SUBJECT: Forwards util revised response to Station Blackout Rule per NRC 920114 Safety Evaluation w/answers attached to all but one NRC recommendation.Query on CR instrument cabinet temp to be answered no later than 920501.

**SUSQUEHANNA STEAM ELECTRIC STATION**
**RESPONSE TO STATION BLACKOUT SAFETY EVALUATION**
**PLA-3745** **FILE R41-2**

# STATION BLACKOUT RULE RESPONSE TO NRC SAFETY EVALUATION

Figure 1

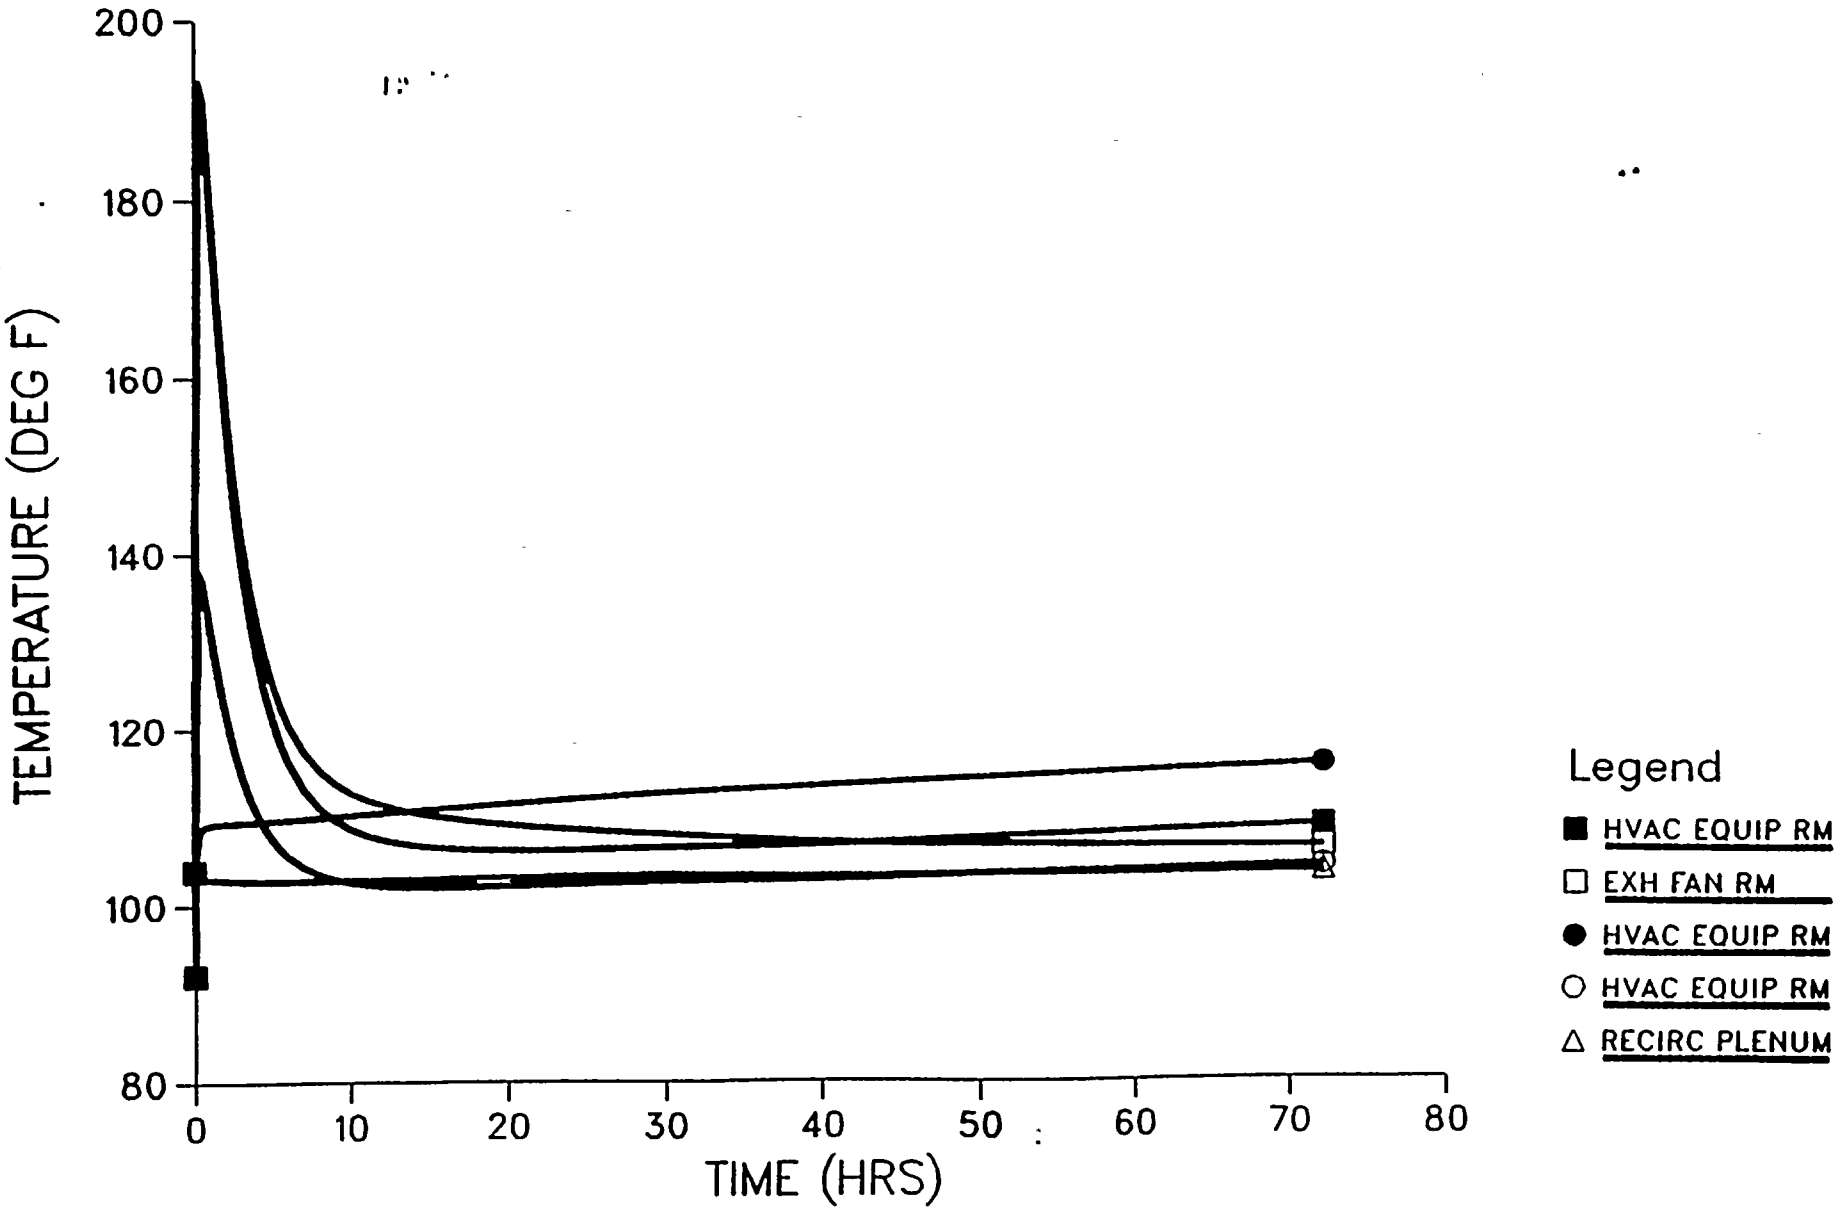
The TER made reference to "oscillatory" temperature profiles. Review of the original COTTAP2 work revealed no such profiles. The reviewers may be referring to temperature profiles which peak and drop in the short term, then continue a long term temperature rise (Figure 1). The large early peak is caused by AC motor heat loads which decay away. At later times, the room is heated by surrounding walls. This result is consistent with expected behavior.
